V2500-D5 SERIES PROPULSION SYSTEMS SERVICE BULLETIN

This document transmits the Initial Issue of Service Bulletin EV2500-73-0174

V2500-ENG-73-0174

ENGINE FUEL AND CONTROL – FUEL FLOWMETER – INTRODUCTION OF A REVISED FUEL FLOW
TRANSMITTER SUPPORT BRACKET

Install the fuel flow transmitter bracket
Fig 1

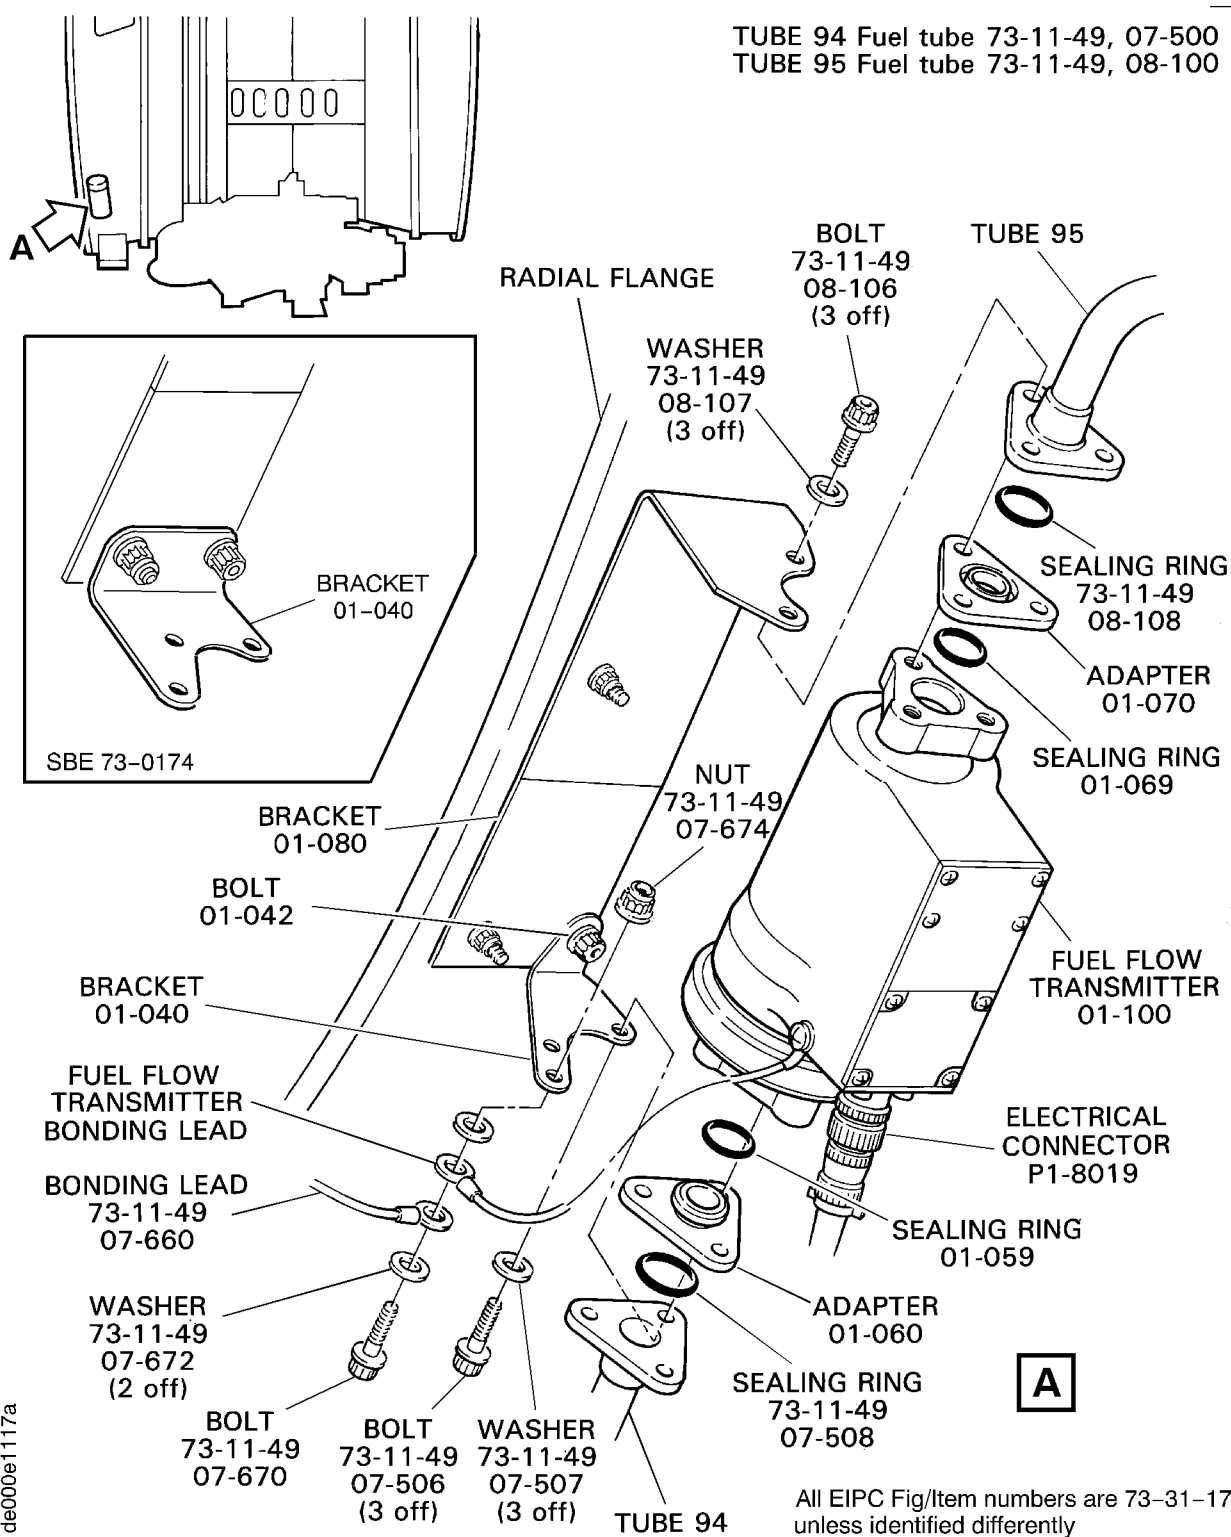
- (1) A revised support bracket is introduced similar to the existing item except for the following:
 - (a) A secondary fixing point has been incorporated.
 - (b) The profile of the bracket has been changed to accommodate the additional fixing point.
 - (c) The fixing points have been changed from plain holes to slots.
 - (d) The material has been changed from titanium to steel.
- (2) The two bolts which attach the bracket assembly to the fancase have been increased in length to accommodate the additional fixing point on the revised support bracket.
- (3) The tightening sequence of the bracket attaching bolts has been defined to prevent pre-stressing of the bracket (see 3. Accomplishment).

- (1) Attach the bracket (73-31-17, 01-040) to its location on the bracket (73-31-17, 01-080) with the bolt and washer (73-31-17, 01-042 and 01-044). Refer to the detail in Fig 1.
- (2) Attach the bracket assembly (73-31-17, 01-080) at the holes 16 and 17 (Refer to Fig 2) with the two bolts (73-31-17, 01-082), and the four washers (73-31-17, 01-084) and the two nuts (73-31-17, 01-086). Refer to the detail in Fig 1. Make sure the bolt inserted at hole 17 passes through the second hole in bracket (73-31-17, 01-040).

Torque the bolts installed in step (1) to 36 to 45 lbfin (4 to 5 Nm)
